Pentium® Processor Specification Update

Release Date: June 1998

Order Number 242480-037

The Pentium® processor may contain design defects or errors known as errata which may cause the product to deviate from published specifications. Current characterized errata are documented in this Specification Update.

2. **Incorrect TCP Pinout Drawing**

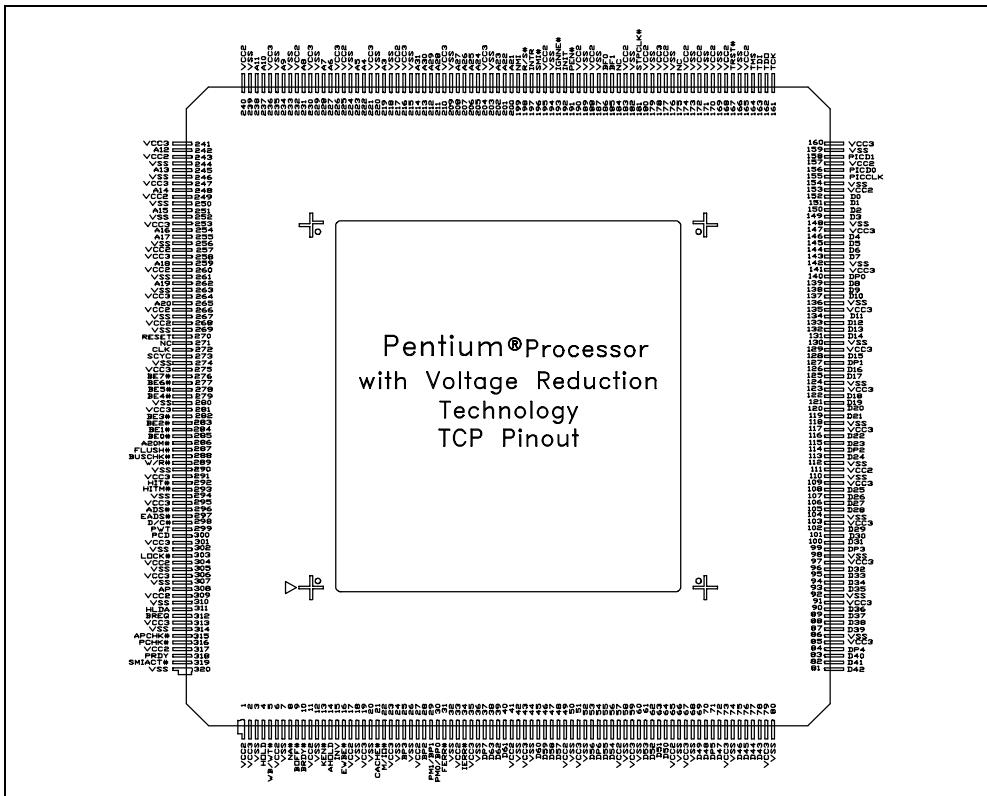
The TCP pinout drawing on page 8 of the *Pentium Processor with Voltage Reduction Technology* datasheet was inadvertently rotated. The correct orientation is shown below.

Figure14-1. Maximum Undershoot Level, Undershoot Threshold Level, and Undershoot Threshold Duration

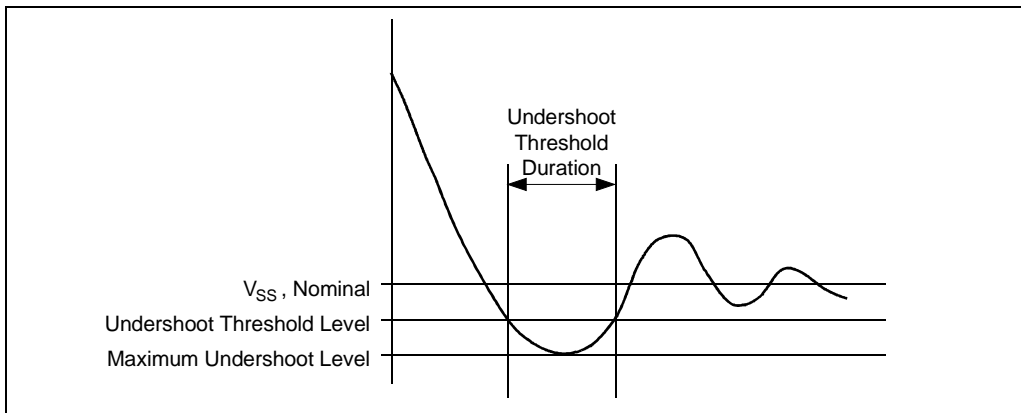
MAXIMUM RINGBACK SPECIFICATION: The maximum ringback of CLK associated with its low state (undershoot) must not exceed 0.8V as shown in Figure 14-1.

MAXIMUM UNDERSHOOT AND MAXIMUM RINGBACK SPECIFICATIONS: The display should show continuous sampling (e.g., infinite persistence) of the waveform at 500 mV/div and 5 ns/div (for CLK) for a recommended duration of approximately five seconds. Adjust the vertical position to measure the maximum undershoot and associated ringback. There is no allowance for crossing the maximum undershoot or maximum ringback specifications.

UNDERSHOOT THRESHOLD DURATION SPECIFICATION: A snapshot of the clock signal should be taken at 500 mV/div and 500 pS/div (for CLK). Adjust the vertical position and horizontal offset position to view the threshold duration. The undershoot threshold duration is defined as the sum of all time during which the clock signal is below -0.5V within a single clock period. The undershoot threshold duration must not exceed 20% of the period.

Figure 14-2. Maximum Ringback Associated with the Signal Low State

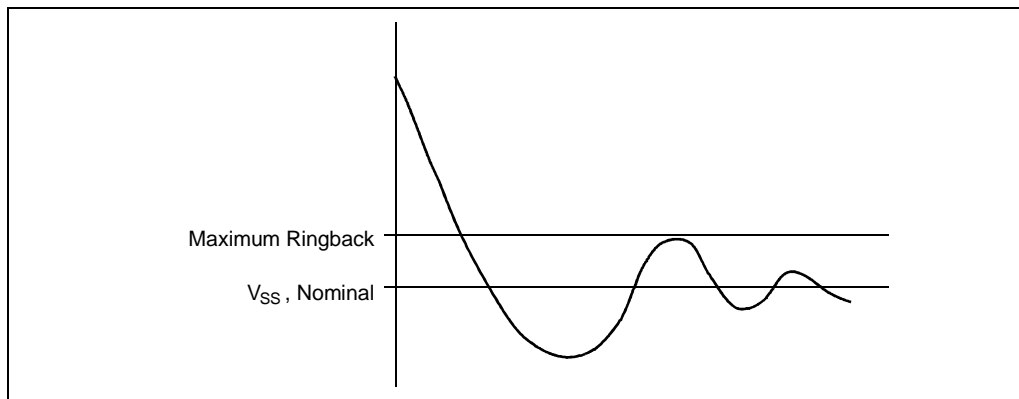
This undershoot specifications are illustrated graphically in Figure 14-1 and Figure 14-2.
